**BEACON PLANNING BOARD**  
**One Municipal Plaza - Courtroom**  
**BEACON, NEW YORK 12508**  
*Phone (845) 838-5002 Fax (845) 838-5026*

The Planning Board will meet on **Tuesday, February 9, 2016** in the Municipal Center Courtroom. A training workshop will take place at 7:00 p.m. and the regular meeting will begin at 7:30 p.m.

Mr. Jay Sheers, Chairman  
and Members of the Planning Board  
City of Beacon  
One Municipal Plaza  
Beacon, NY 12508

Re: Response to Engineer and Consultant Comments

**1 GRADING & UTILITY PLAN**  
Scale: 1" = 20'

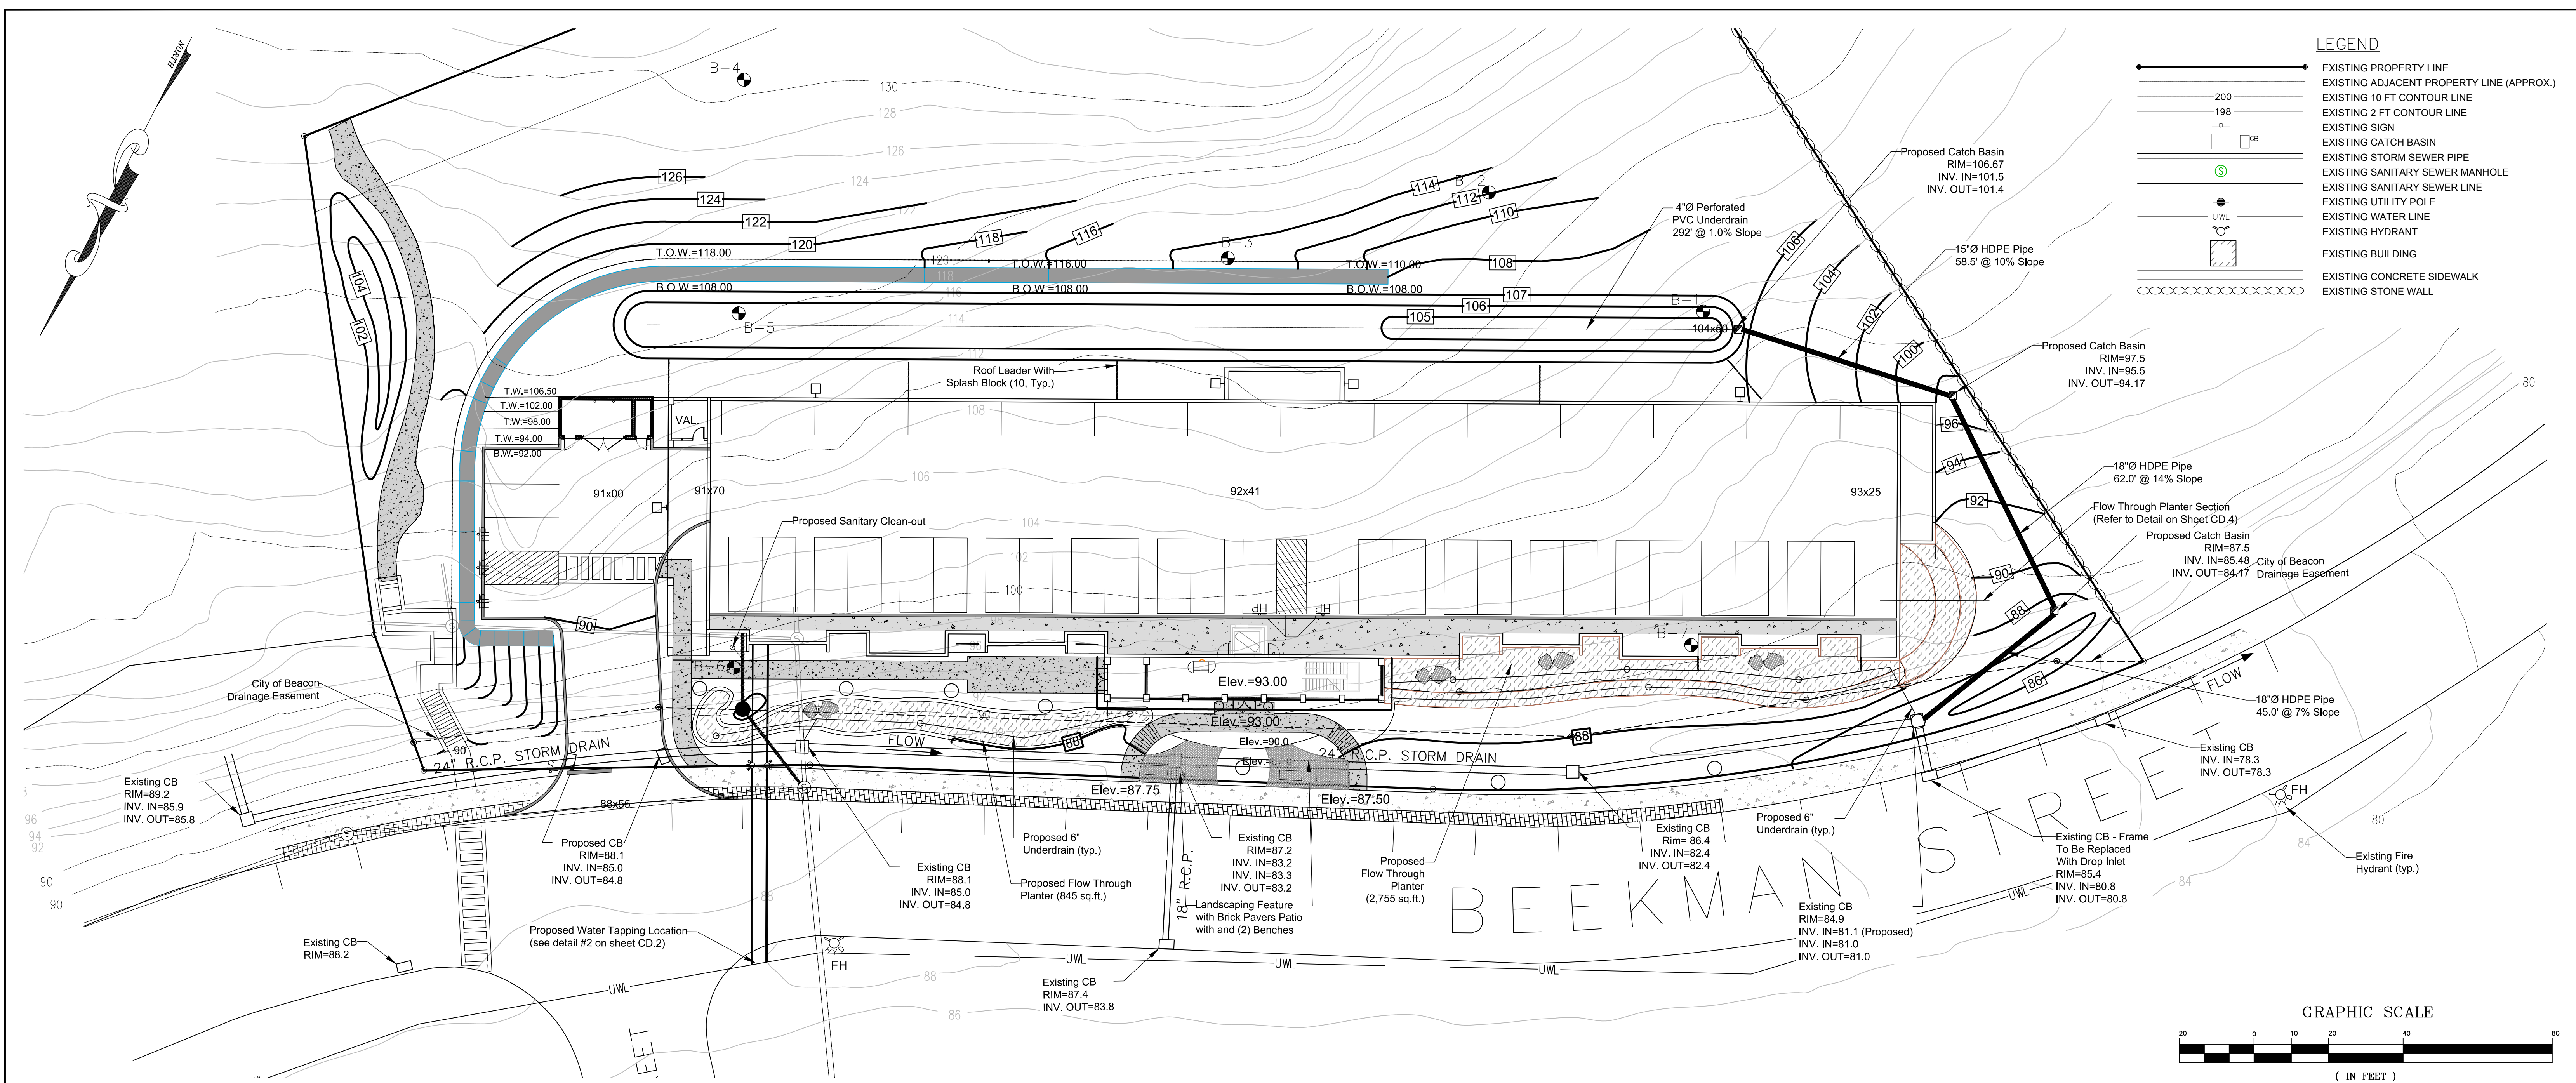
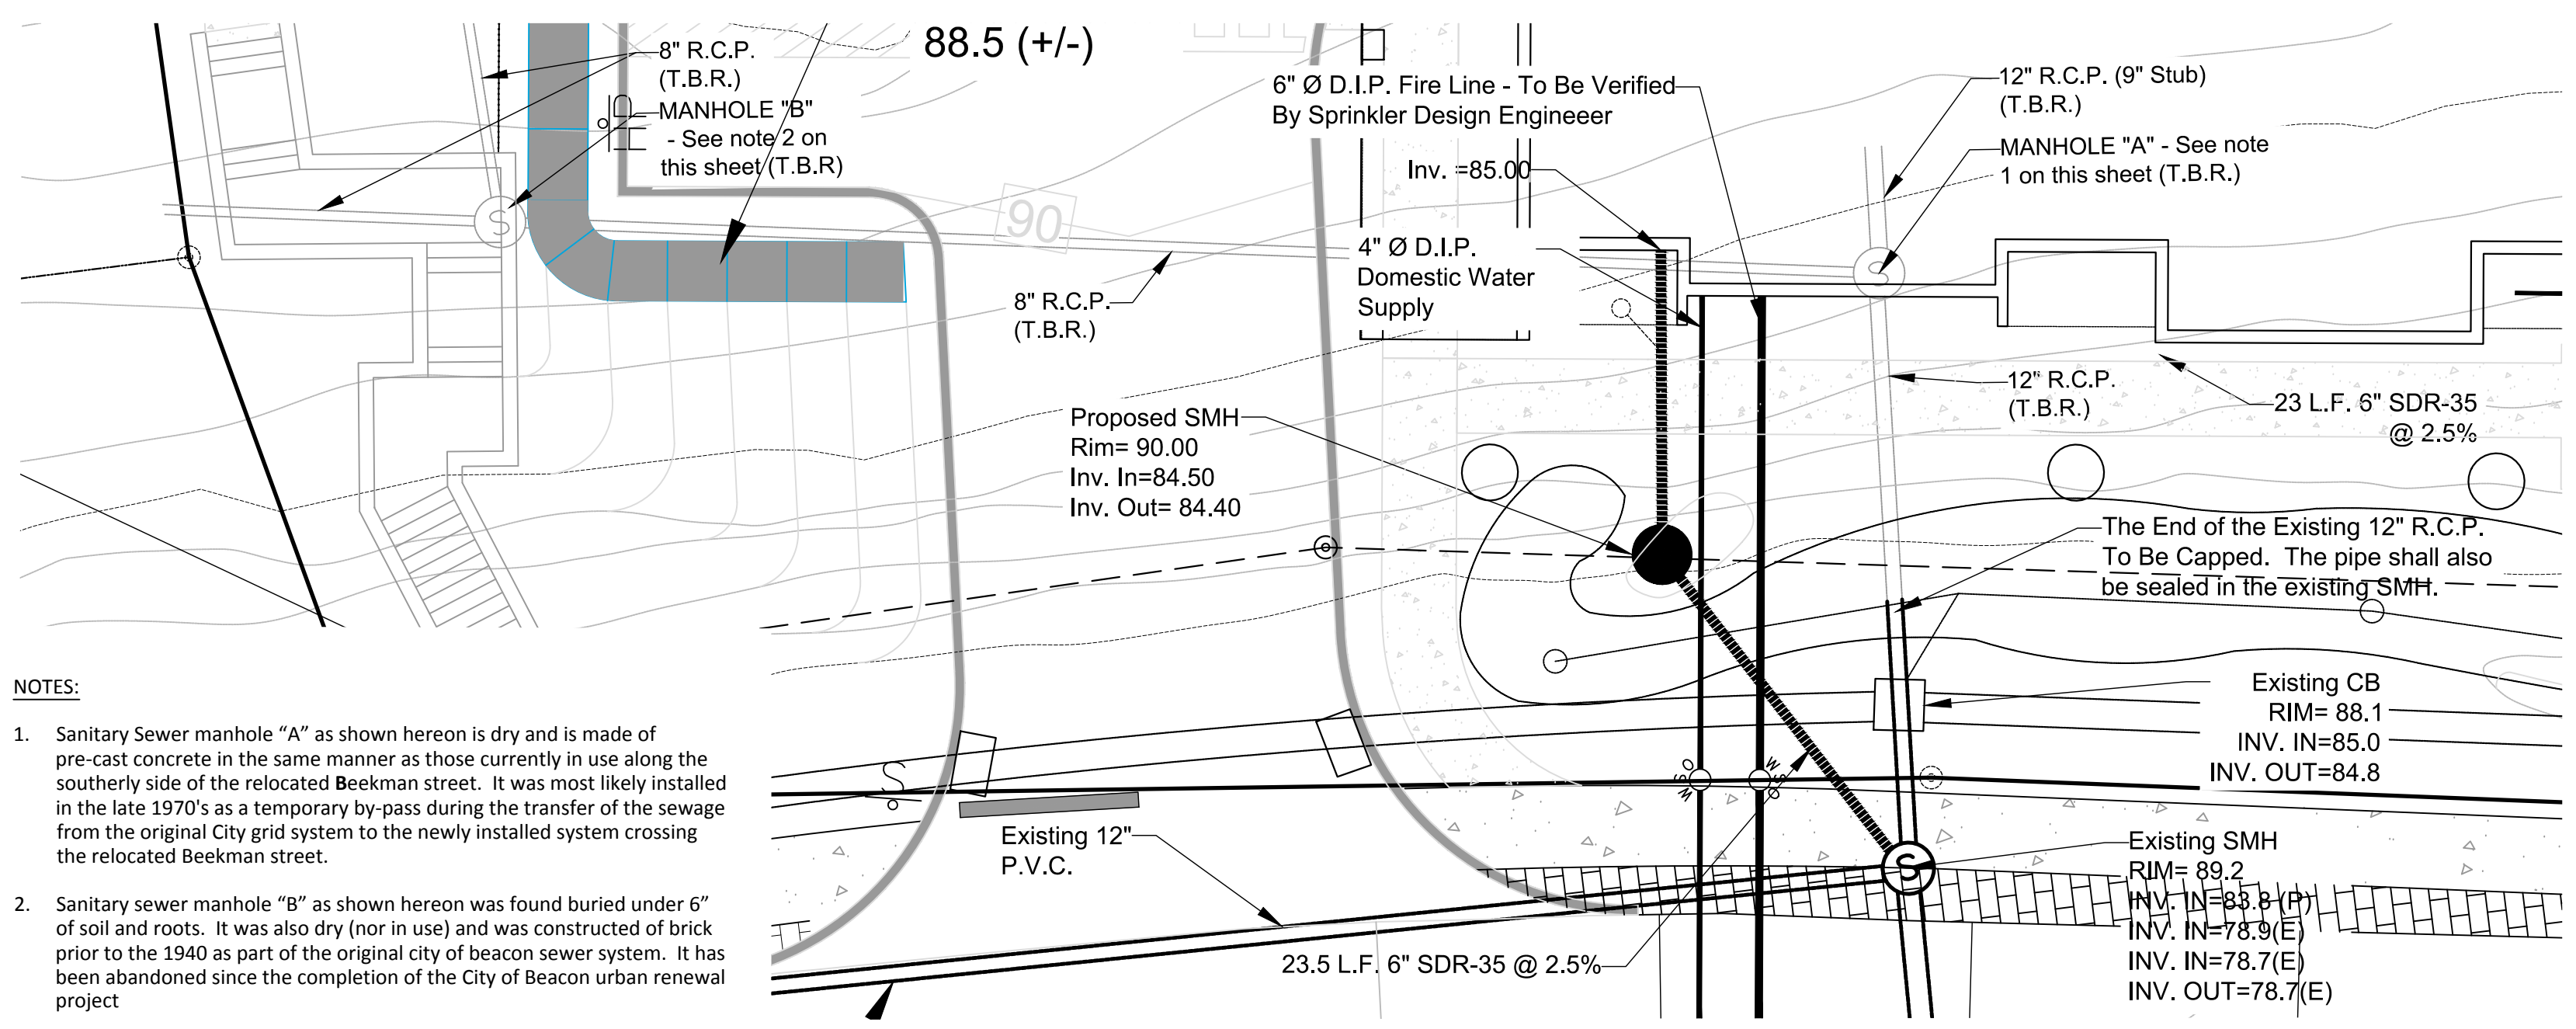
2. The construction detail for the stormwater planters on sheet 10 describes 3 levels within the stormwater planters separated by retaining walls. The locations of these walls on are not clear on the plans, as line types for what appear to be retaining walls match other lines in the area. The number of levels in the two front stormwater planters appear to have only 2 levels, not matching the construction detail. It should be clarified if 3 levels will be constructed for all stormwater planter areas.

1 ROOFTOP GARDEN DETAIL  
NOT TO SCALE

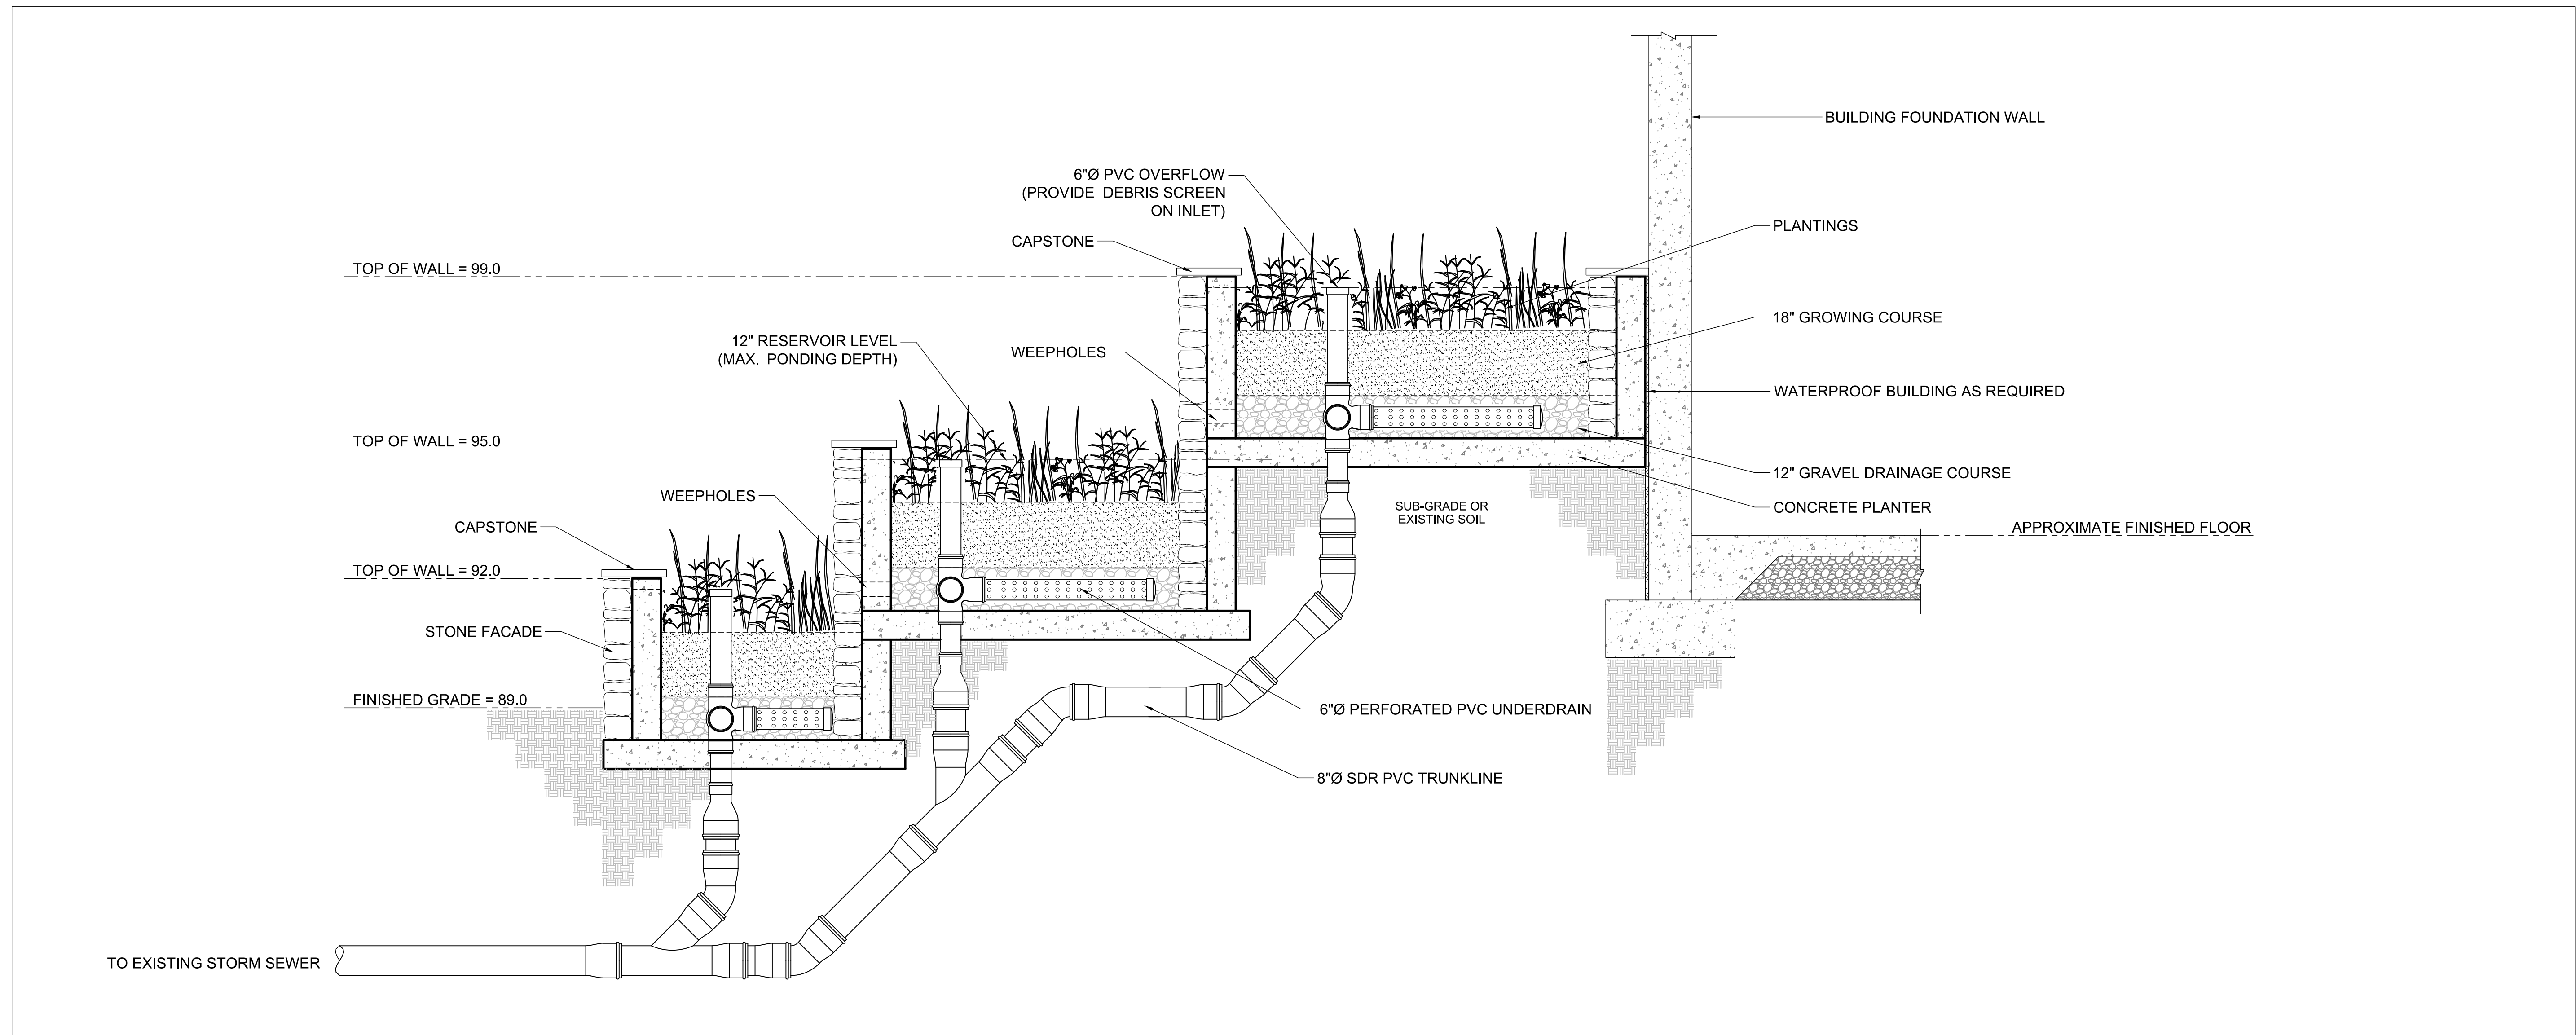
7. The Applicant has noted that a 3,500 square foot rooftop garden is proposed for the building. The garden and all details necessary for the garden should be included in the plan set.  
**Response: Additional details have been provided in the plan set on sheet CD.4 of both the green roof and flow through storm water planters.**
